SHELTER BAY ESTATES
Draft Environmental Impact Statement

Montana Department of Health
and
Environmental Sciences
Final
Environmental Impact Statement

Shelter Bay Estates
Lake County

SUBSTANTIVE COMMENTS AND RESPONSES

MAP #2

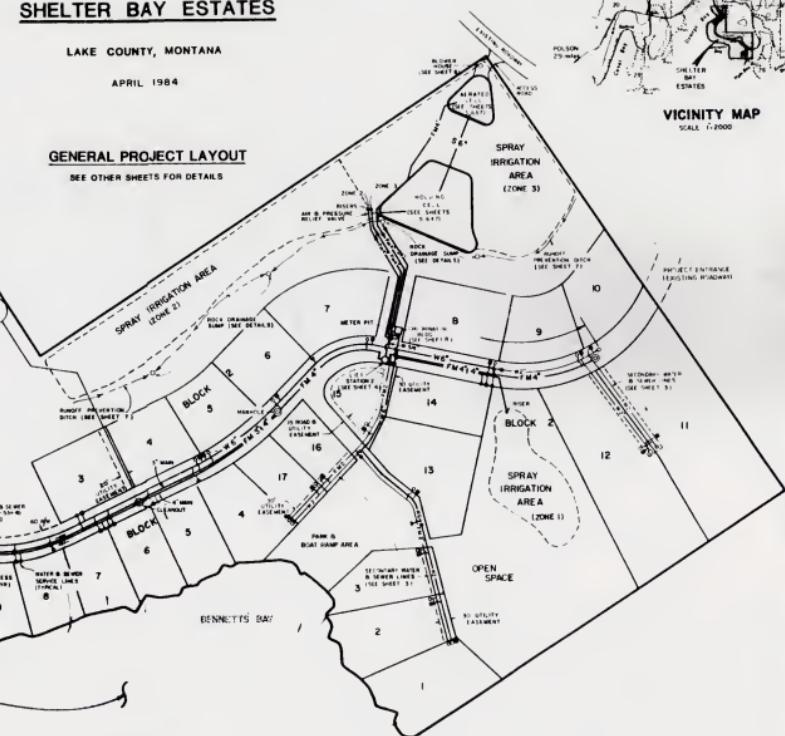
3. What will be the impact of stormwater runoff upon Flathead Lake? What is the total runoff estimate? What will be the effect of sediments on fisheries? If the water supply system does not provide adequate water quantity for irrigation, then how can reseeding be accomplished in an efficient manner? (p. 17, p. 46, p. 77-78 p. 93, Public Meeting Transcript; Ennis' written comments; Billmayer's written comments (Appendix D)).

3. Storm drainage impacts are not adequately addressed in the plans. The draft EIS on page 18 last paragraph indicates the engineer's design employs overland flow from out sloped roadways to control sediment and debris transportation in a majority of the area. This method of construction does not address the increased runoff potential due to cut slopes, increase of runoff volume resulting from a change of ground cover characteristics, or site grading changes resulting from housing and driveway construction. The drainage report does not adequately address the containment volume and absorption of storm water at the subsurface sump associated with the road cut and the boat ramp area.

Wherever possible, roadways are outsloped so that stormwater runoff will remain dispersed. If flow is not concentrated in a borrow ditch, sufficient soil permeability is present to absorb runoff before it reaches the lake. Existing roadways within the subdivision have been constructed utilizing this same method and no visible erosion or slides have occurred due to runoff. The regrading of the existing roadway should not change this condition. Section 02990 of the project specifications requires reseeding and fertilizing cut and fill slopes of new construction areas. Seed application is to occur in the fall between September 15 and November 15.

The probability of increased stormwater runoff above and beyond current runoff levels from this property has been addressed by the project engineers and those reviewing their submittal. If the "Rational Formula" is utilized to estimate runoff quantities, different quantities can be obtained by varying the coefficient of runoff "c" and the rainfall intensity "i". Depending on the source of one's data, coefficients of runoff between 0.15 and 0.50 could be utilized in estimating existing condition runoff. There are at least 3600 feet of existing bare to gravelled roadway within the subdivision site. Vegetation varies widely from sparse grasses to dense underbrush. Soils are gravelly loams with moderate permeability. An average runoff coefficient for existing conditions should be 0.25 to 0.30.

Map #3

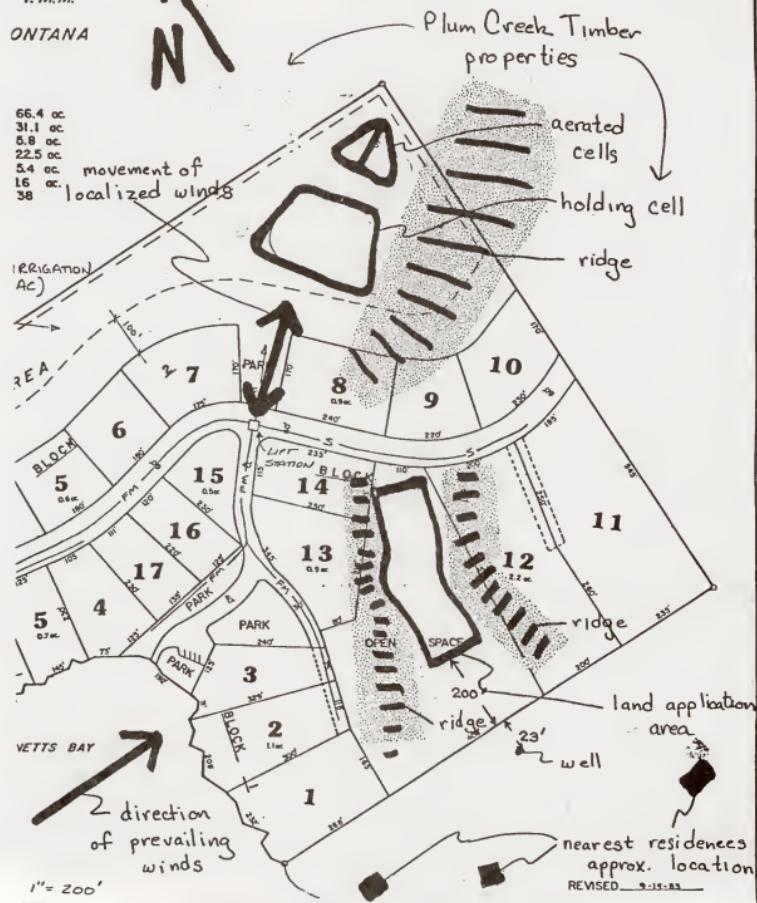
1. Will there be offensive odors associated with the wastewater treatment system? (p. 11, Public Meeting Transcript (Appendix B); Ennis' written comments (Appendix C)).

Odors normally associated with facultative lagoon systems should be minimized or eliminated by the design of the Shelter Bay Estates treatment system. Primary treatment is provided by common septic tanks prior to

The topography, forest cover and wind patterns should minimize the transfer of odors to nearby property owners if odors should develop from equipment breakdown or improper operation of the facility. The attached map (map #3) indicates the approximate location of the sewage lagoons relative to the nearest home and proposed lots. A significant ridge is shown to the south of the lagoon. Prevailing and localized wind patterns are labeled. Homesites within Shelter Bay Estates are located at least 150 feet from the land application zones and the lagoon. It is common practice in Montana and elsewhere in the United States to spray treated sewage effluent on recreational developments such as golf courses. Therefore, land application of disinfected sewage upon the semi-isolated areas shown should have no groundwater or air quality impacts.
